Remarks/Arguments

Examiner in the Office Action of October 5, 2004, objected to the disclosure because of certain informalities. The following amendments address Examiner's objection.

Corrected Drawings

Replacement drawing sheets, without markings are attached as Attachment A. The replacement drawings contain no new matter. Annotated drawing sheets showing the changes are attached as Attachment B. An explanation of the changes is included in the Remarks/Arguments section of this paper.

Figure 1

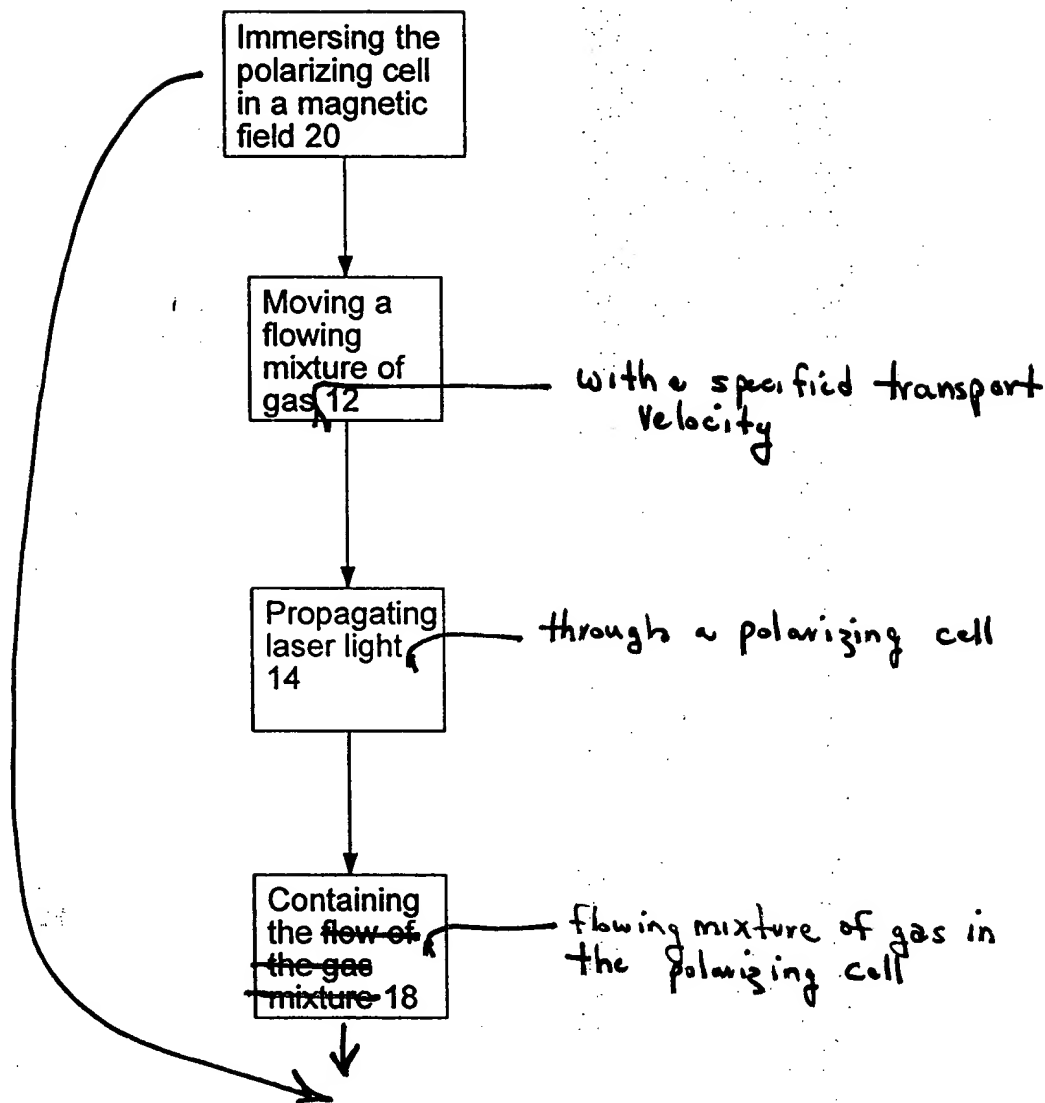
FIG. 1 is corrected, as shown, so that the wording of the steps matches more closely the wording of the specification. (specification, page 7, line 5, paragraph beginning – “The present invention...”) The order of the steps is revised so that they appear in numerical order although the steps can be initiated in any order (specification, page 7, lines 11-12).

Figure 2

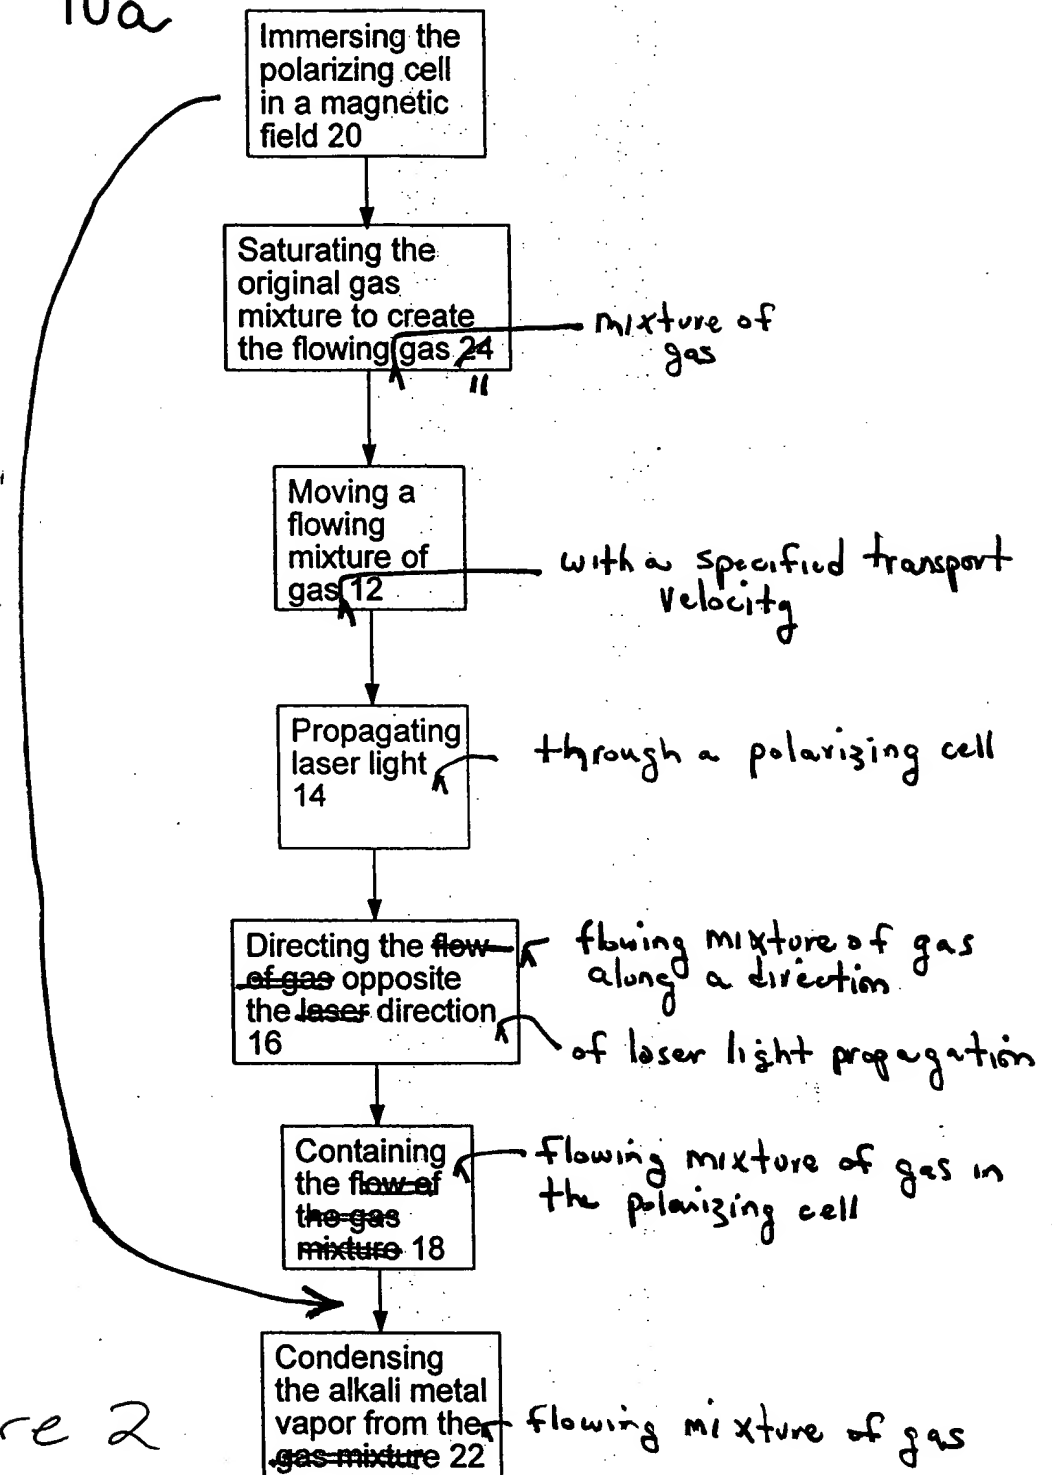
FIG. 2 is corrected to refer to embodiment “10a” to distinguish the embodiment from that shown in FIG. 1. Corrections are made to the wording of the steps so that they match more closely the wording of similar steps in FIG. 1 and the wording of the specification. The order of the steps is revised so that they appear in numerical order although the steps can be initiated in any order.

Figure 3

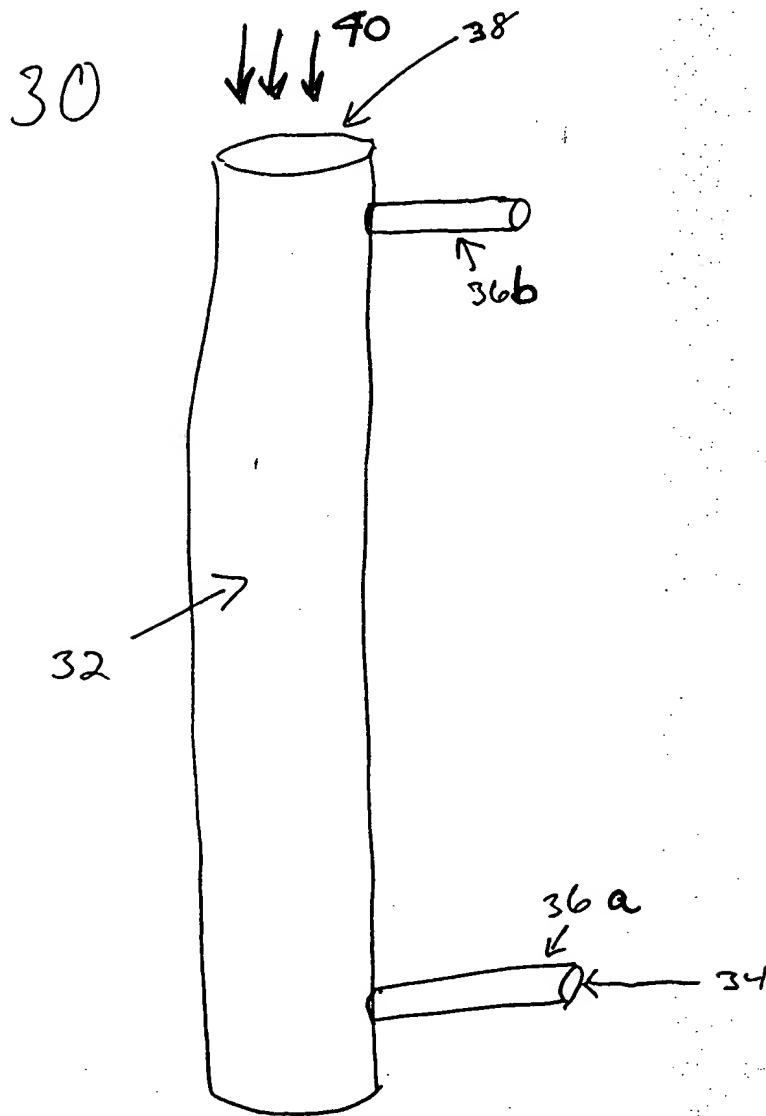
FIGS. 3-6 are corrected as shown an “entrance 36a” and an “exit 36b” instead of two openings 36. No new matter is added as FIG. 4 shows the flowing mixture of gas flow in

direction 54 (specification, page 13, line 3-4) which requires the opening now referred to as 36a to be the entrance opening and the opening now referred to as 36b to be the exit opening.

Figure 4
4/6

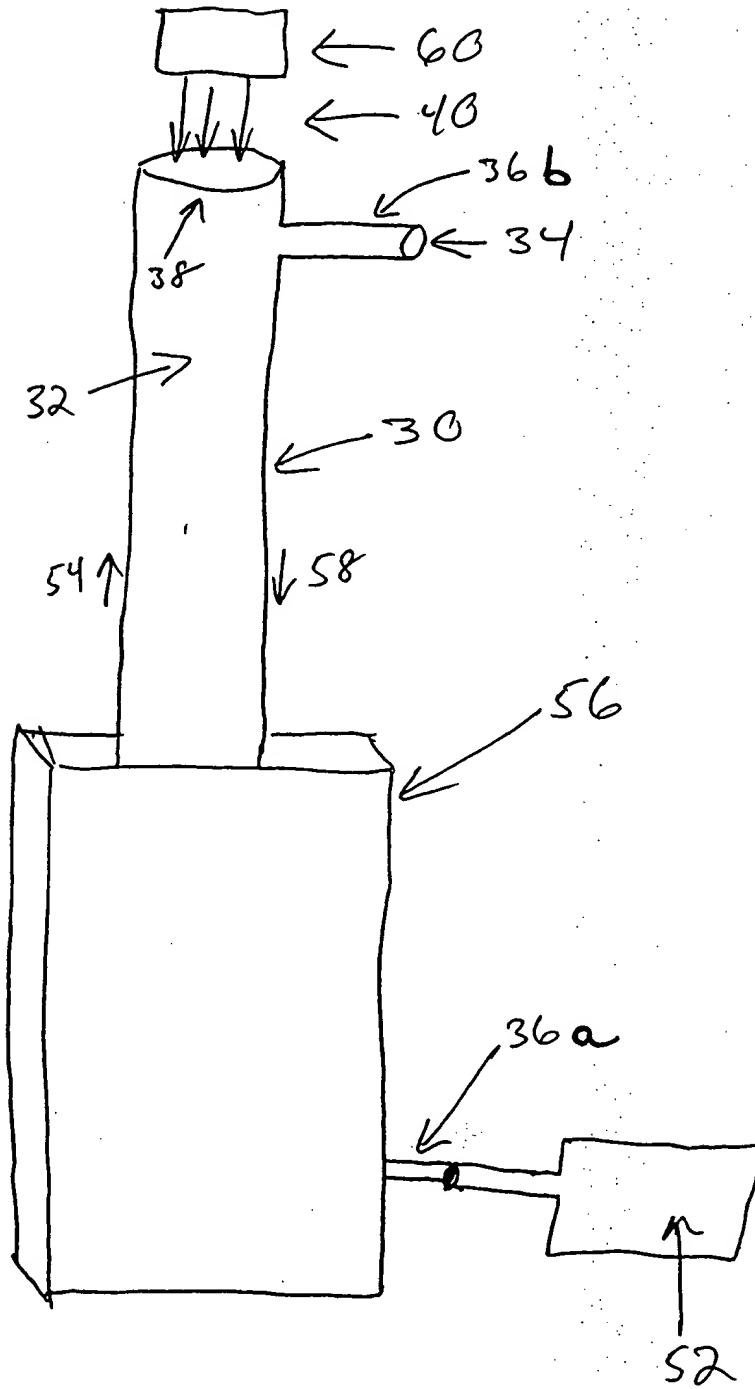
Page 16, lines 21-22, the reference character 36 is amended so that the specification reads "from the entrance opening 36a to the exit opening 36b..." No new matter is added as FIG. 4 shows the flowing mixture of gas flow in direction 54 (specification, page 13, lines 3-4), which requires the opening now marked 36a to be the entrance opening and the opening now marked 36b to be the exit opening.

Figure 5
5/6

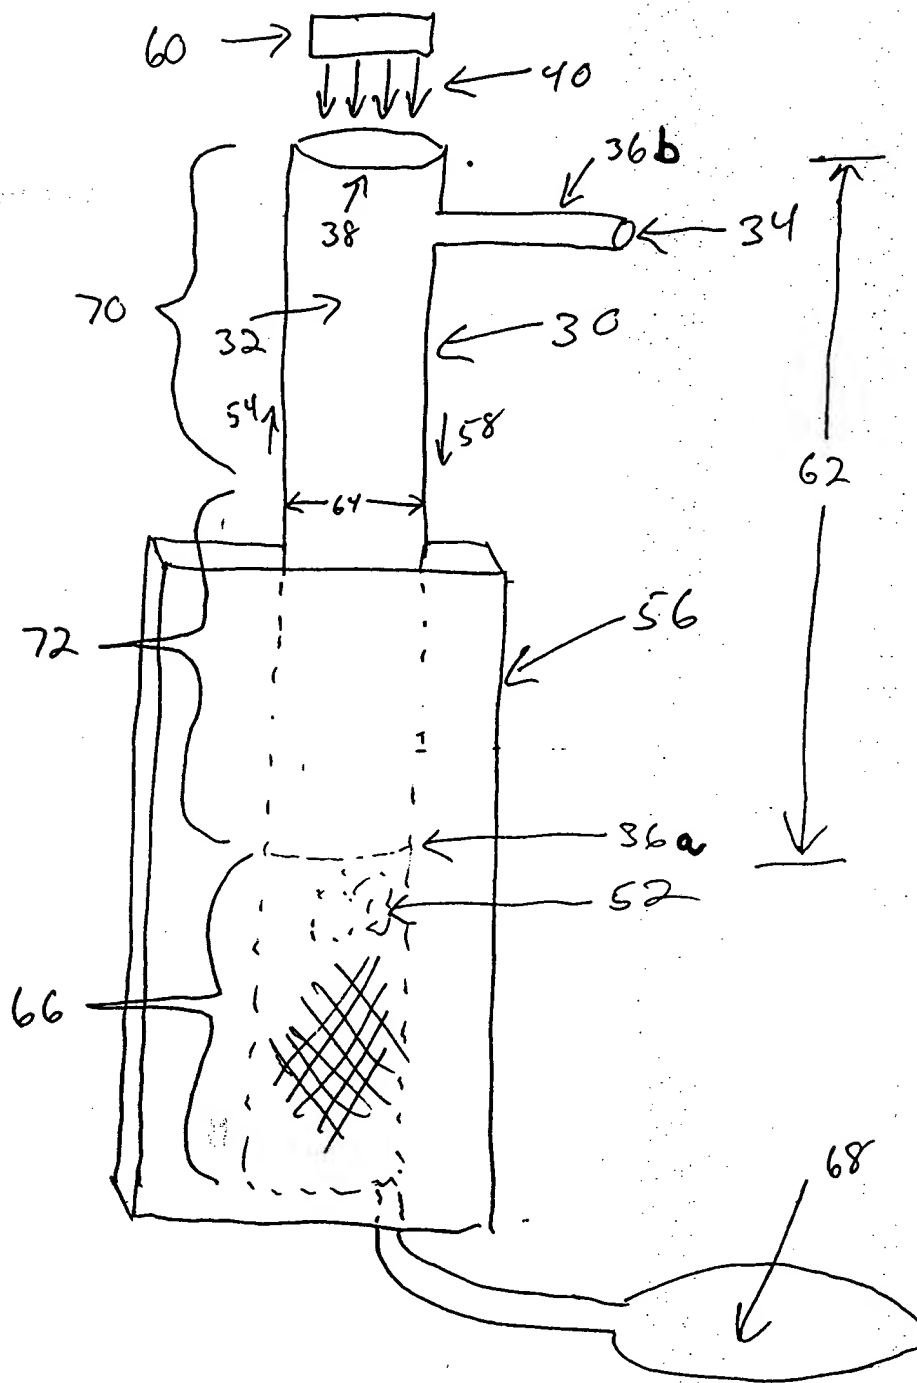
Page 18, line 1 -- Corrections are made to refer to “the unextended portion 72, “which is shown on FIG. 5.
